HISTORIC AND DESIGN REVIEW COMMISSION

HDRC CASE NO: 2017-384
ADDRESS: 2500 E COMMERCE ST
LEGAL DESCRIPTION: NCB 1442 BLK LOT ALL OF NCB
NCB 155 BLK LOT 35
ZONING: C-1, UZROW,D
CITY COUNCIL DIST.: 2, 1
APPLICANT: USA Shade
OWNER: City of San Antonio
TYPE OF WORK: Installation of new playground shade structure
REQUEST:

The applicant is requesting a Certificate of Appropriateness for approval to install a new shade structure over an existing public playground.

FRONT ELEVATION
(SCHEMATIC VIEW ONLY)

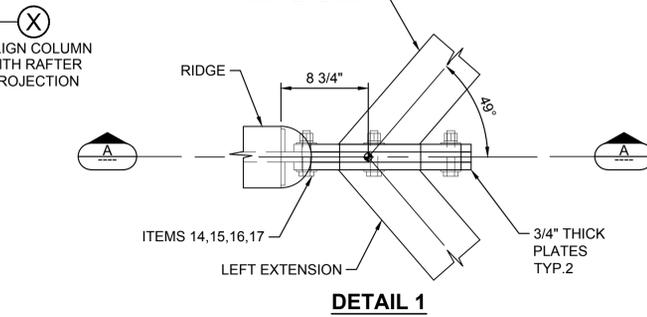
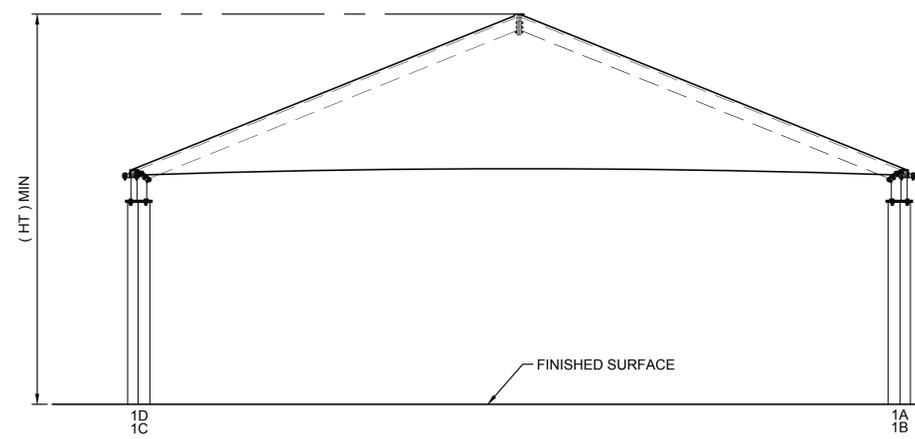
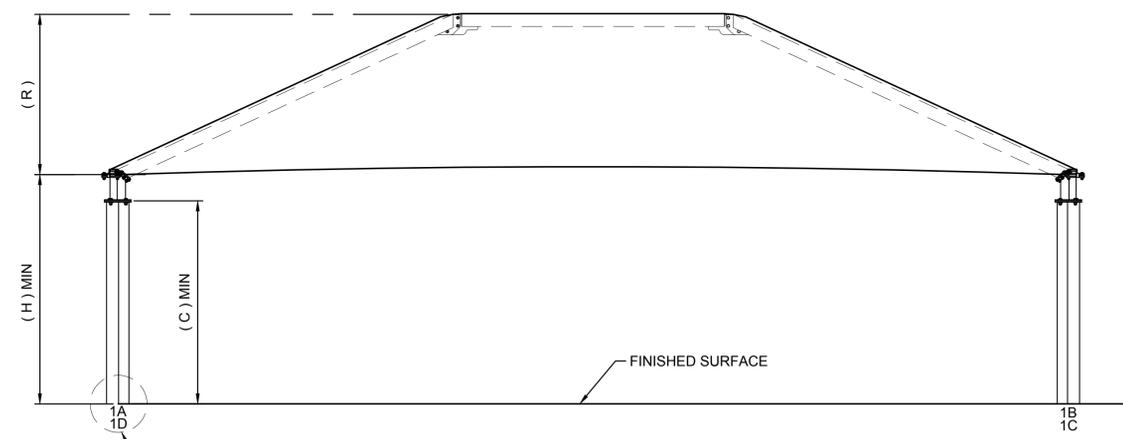
- b. LOCATION AND SIZE – The proposed shade structure will measure approximately 50 by 50 feet in width and length and 16 feet in height. The structure will be installed over playground and green space, which is surrounded by a circular pedestrian pathway. The proposed structure is consistent with the UDC guidelines for massing, size, and setting. The structure is primarily intended to provide shade and weather protection to pedestrians, which is consistent with UDC Section 35-646.

- c. MATERIALITY – The proposed shade structure will be constructed of a high density polyethylene fabric. The fabric has been fire tested and has met ASTM E 84 standards. The structure will be supported by structural galvanized steel columns and wire rope cables. The proposal is consistent with the preferred materials for awnings and canopies as outlined in UDC Section 35-646.

Staff recommends approval based on findings a through c.
